REFERRAL REPORT

TO: Vancouver City Council
FROM: General Manager of Planning, Urban Design and Sustainability
SUBJECT: CD-1 Rezoning: 1111 Broughton Street

This application proposes to rezone the site at 1111 Broughton Street from RM-5 (Residential) District to CD-1 (Comprehensive Development) District. The proposal is to permit a 25-storey residential building with rooftop amenity, containing 136 social housing units, under the *West End Rezoning Policy* (the “Policy”).

Levels 2 to 5 Floor Plan

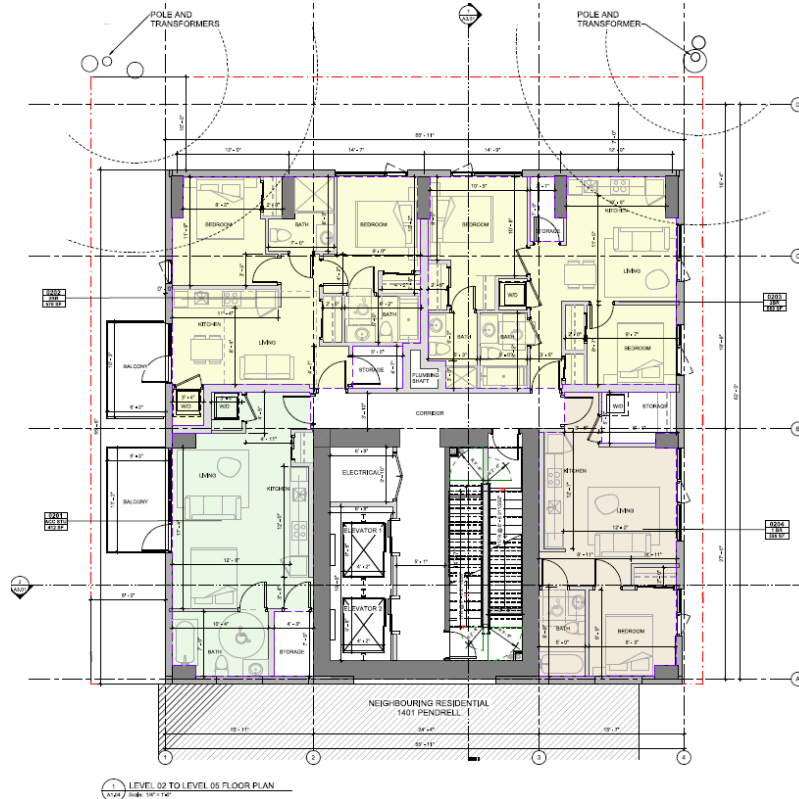
- (d) Provide balconies for the 2-bedroom units in levels 2 to 5 facing Jepson-Young Lane; and
- (e) Provide Juliet balconies for the studios and 1-bedroom units along Jepson-Young Lane and Broughton Street.

Landscape Plan, Main Floor

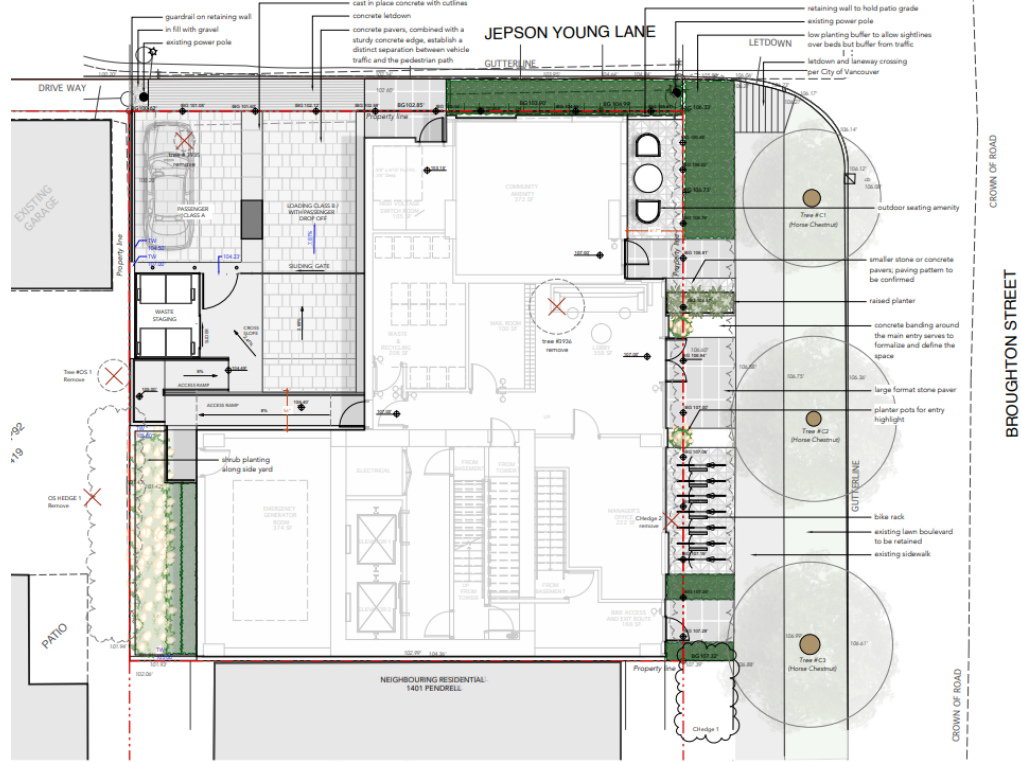
- 1.6 Design development to improve the overall landscape and public – private realm interface;

- Delete the proposed bike rack and raised planter that are shown encroaching over City property, and the surface treatment in hardscape areas in City property should meet the Engineering requirements, refer to Engineering condition 1.18;
- Ensure the proposed planting on City property does not exceed a height of 1 m, or is kept low through trimming, refer to *Boulevard Gardening Guidelines*;
- Create a more functional outdoor space in the southwest corner of the side yard to eliminate unused or dead space.

Landscape Plan, Rooftop

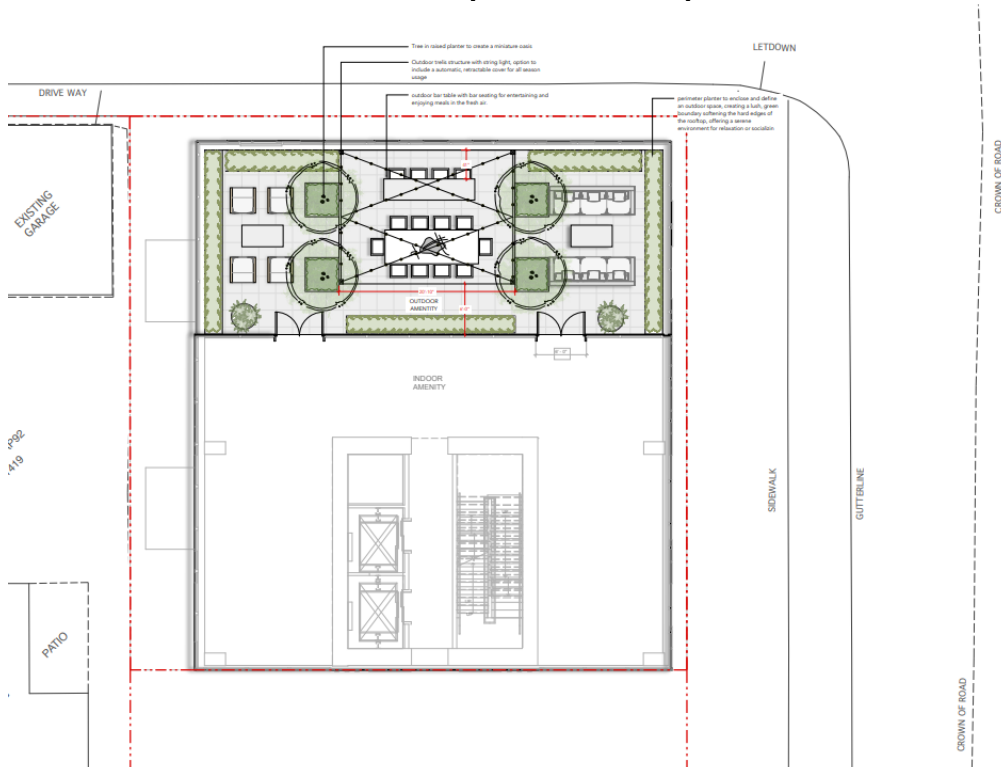
- 1.4 Design development to provide a more functional and appropriately sized residential outdoor amenity space;

- (a) Enhancing the size of the roof-top outdoor amenity area where possible to achieve closer to 2 sq. m (20 sq. ft.) per unit to better serve the residents needs.
